**R02GC**

This notice is sent to you in accordance with the requirements of the National Traffic and Motor Vehicle Safety Act. Blue Bird Body Company has determined that a defect, which relates to motor vehicle safety, exists in certain Blue Bird Blue Bird TC/2000 and All American school and transit buses and Commercial Series transit buses equipped with Allison 2000 Series transmissions. Affected buses were manufactured from January 01, 2000 through June 21, 2002.

## RECALL R02GC 'RANGE INHIBITED' LIGHT ACTIVATION INSTRUCTIONS

**Figure 2**

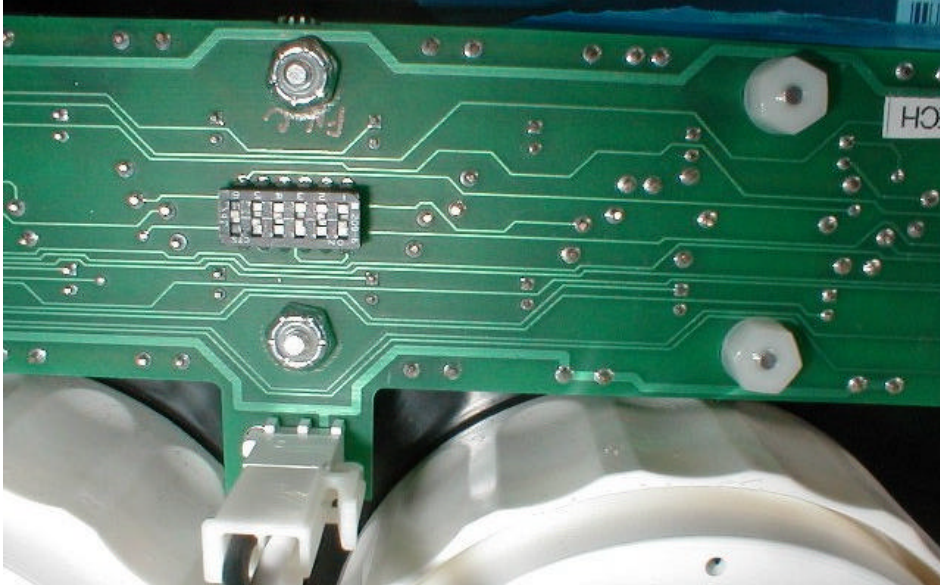
6. When sitting in the driver's seat and leaning over the dash panel, the dipswitch position 6 will be on your left and the dipswitch position 1 will be on your right. See Figure 2 below.

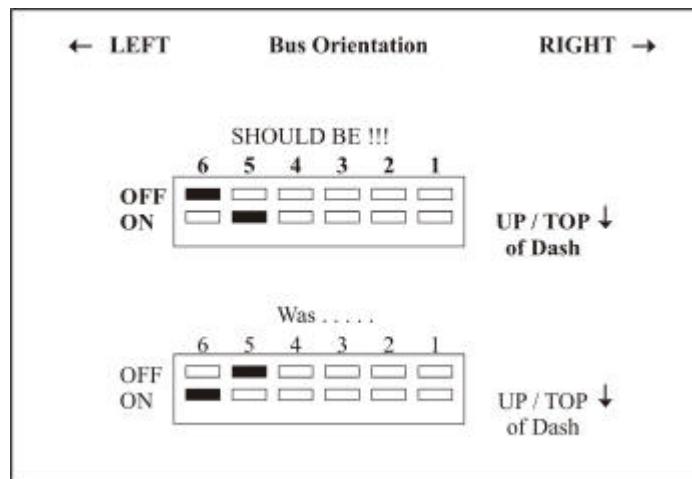
7. Flip switch 6 to "off" position. Down towards bottom of dash panel. Flip switch 5 to "on" position. Up towards top of dash panel. See Figure 3 below.

8. You should verify that the change was made correctly. This can be done by using the following steps.

- A. Turn the ignition switch to "ON" position.
- B. Observe that the "Range Inhibit" light comes on for a few seconds and then goes off.
- C. Observe that the "Trans Temp" light does not come on at all.
